Meadow Springs Pump Station Wells No. 1 and No. 2 RFCSP
Solicitation Number: CO-00637
Job No.: 22-6025

ADDENDUM 2
July 11, 2023

PLAT NO.	N/A
JOB NO.	11650-00
DATE	MARCH 2023
DESIGNER	RG
CHECKED LN	DRAWN AL
SHEET	C7.03

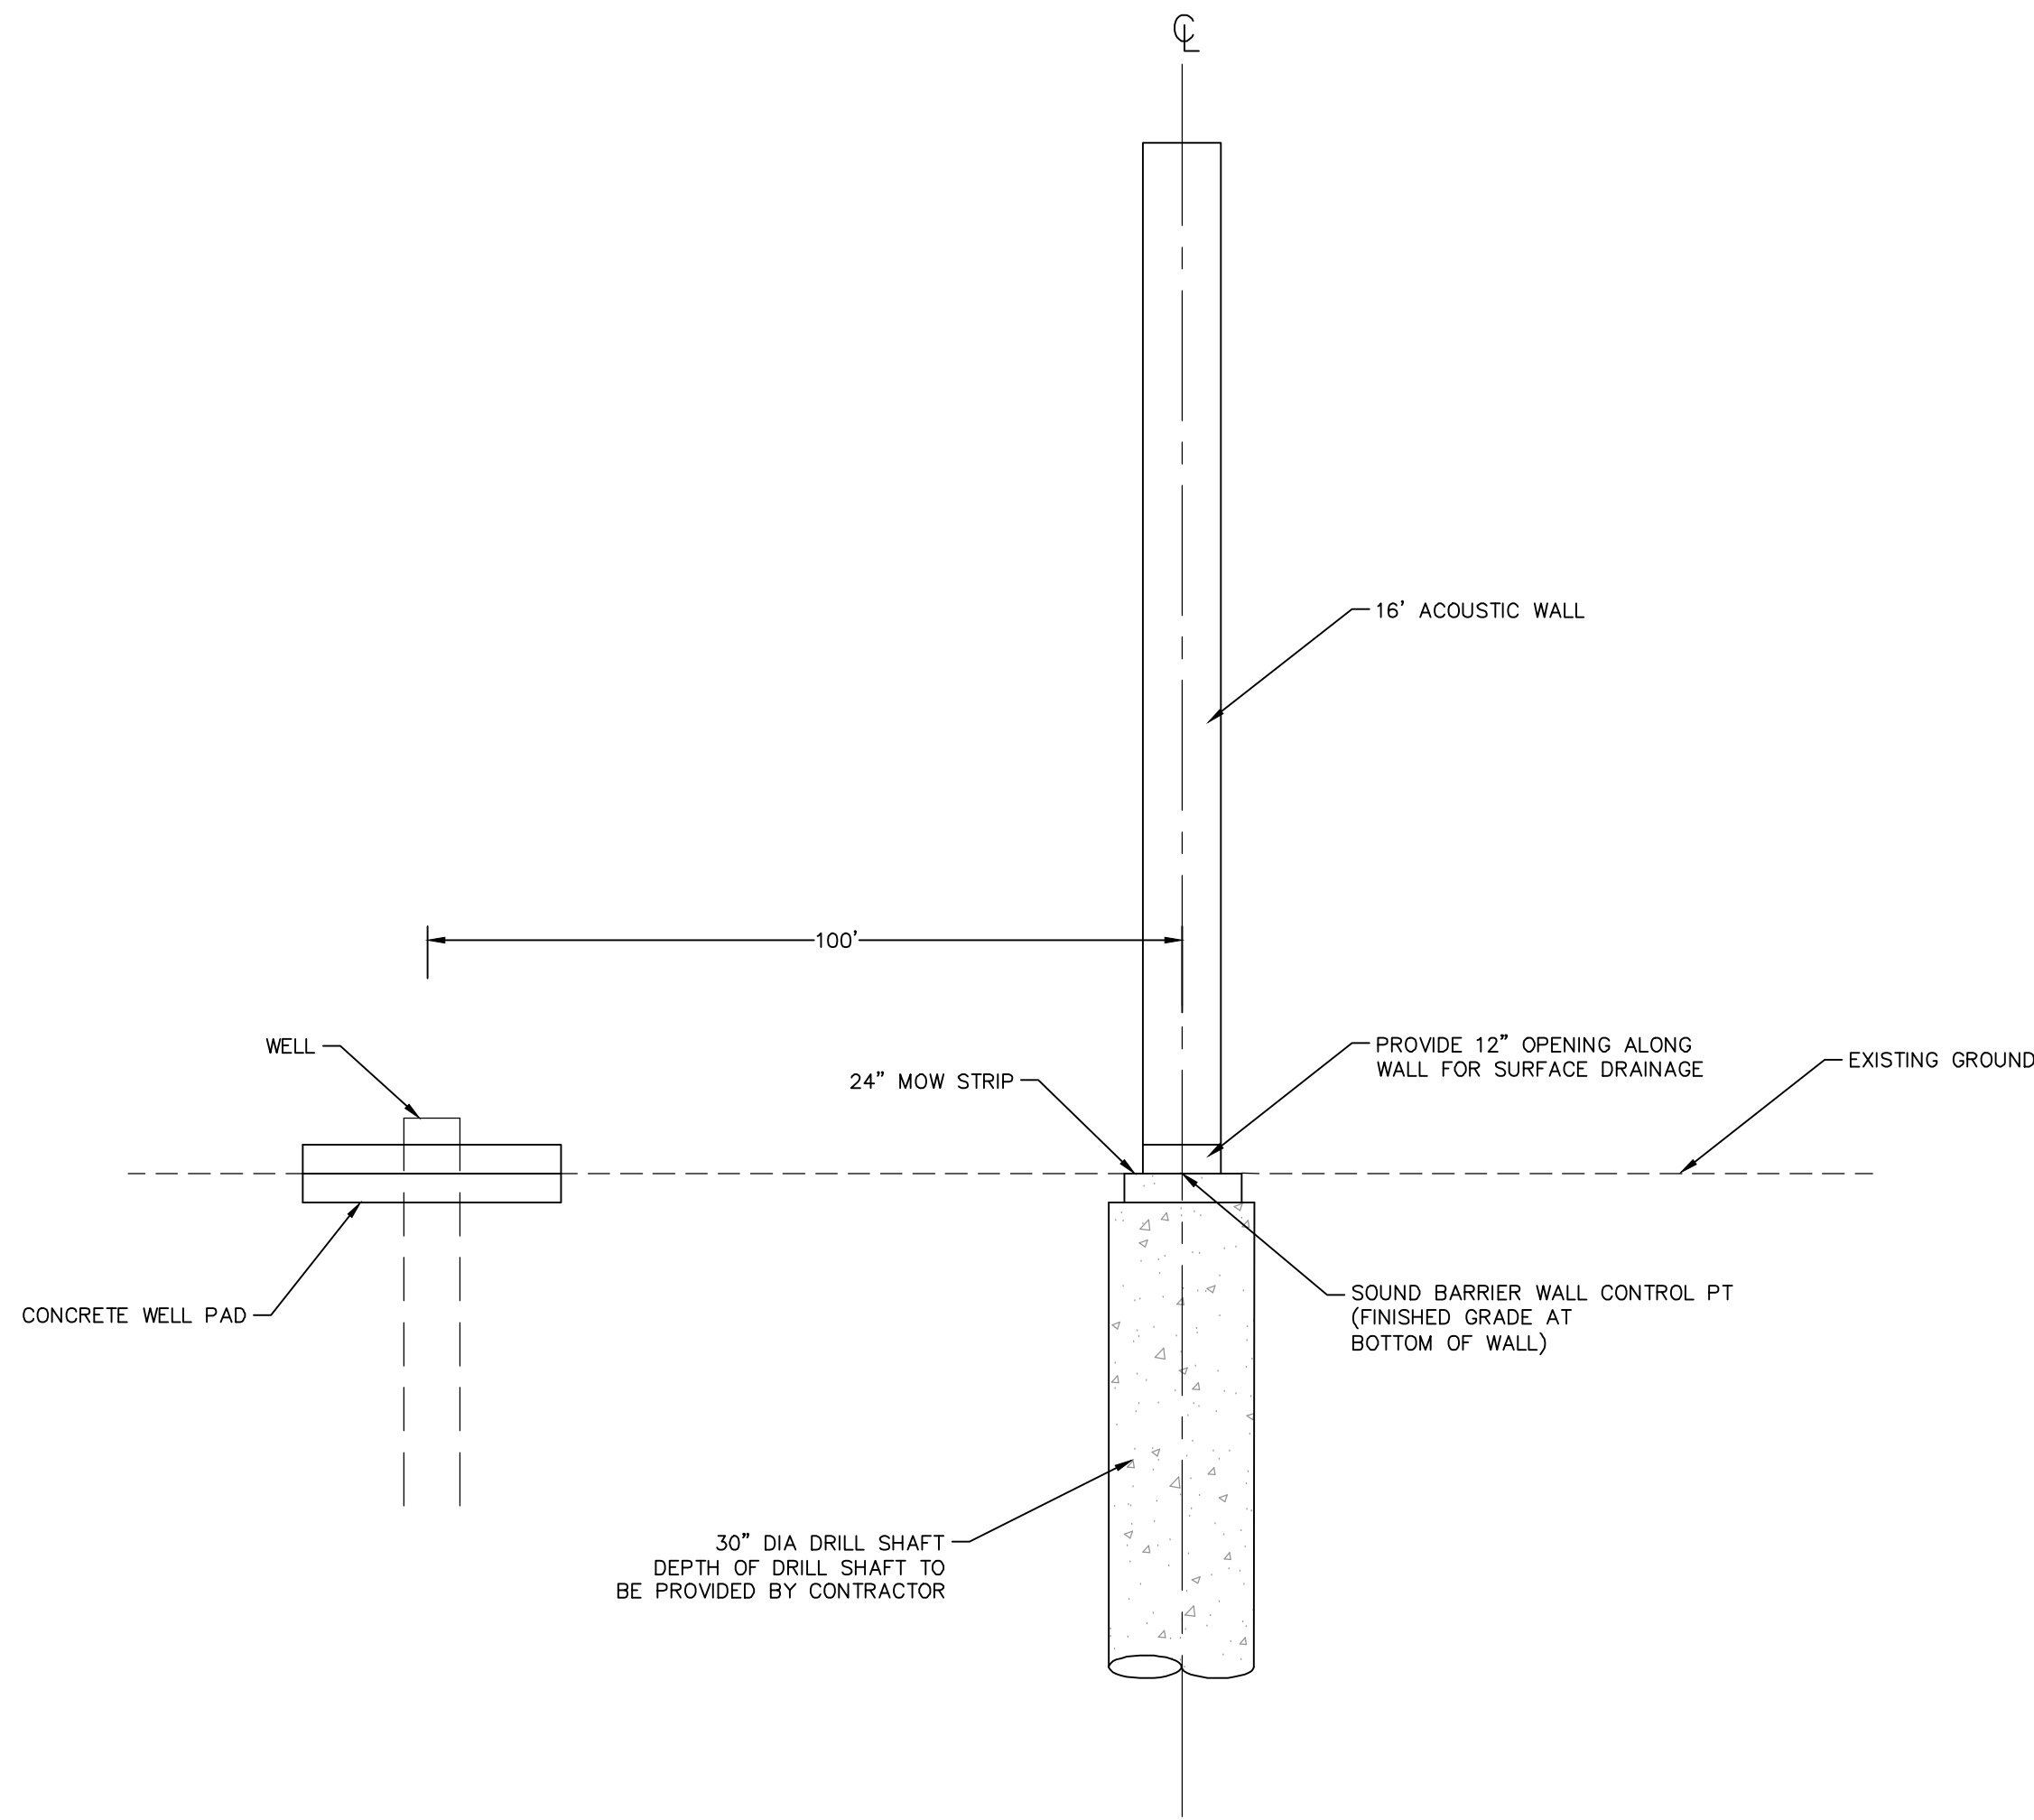
1. Do you have specs for the acoustic wall barriers on sheet C3.01, C4.01, C6.01, C6.02?
Response: Refer to new sheet C7.03 attached to this Addendum.
2. Where will the water connection to the SAWS water mains be located?

3. When will the acoustic walls be installed? Have details been prepared?
Response: Contractor to provide and install acoustic wall barriers as shown on drawings. Construction shall be as shown on new sheet C7.03 attached to this Addendum. Contractor shall install acoustic walls prior to starting drilling operations for each well.

7. Due to the close proximity of the Project to residences, should Contractor plan on furnishing and installing sound walls?
Response: Contractor will be required to provide and install acoustic sound barrier walls. Refer to new sheet C7.03 attached to this Addendum.

17. Specifications require 24' tall sound walls while the drawings show 16' minimum.

Response: The Acoustic sound walls shall be 16' height. Refer to new Sheet C7.03 attached to this Addendum.

6. C6.01 Add Addendum #2 – revised entrance location and gravel drive alignment. Remove Sheet C6.01 in its entirety and replace with the Revised Sheet attached to this Addendum.
7. C6.02 Add Addendum #2 – revised entrance location Remove Sheet C6.02 in its entirety and replace with the Revised Sheet attached to this Addendum.
8. C7.02 Add Addendum #2 – revise fence detail description Remove Sheet C7.02 in its entirety and replace with the Revised Sheet attached to this Addendum.
9. C7.03 Addendum #2 - Add this sheet to project drawings. Add Sheet C7.03 attached to this Addendum.
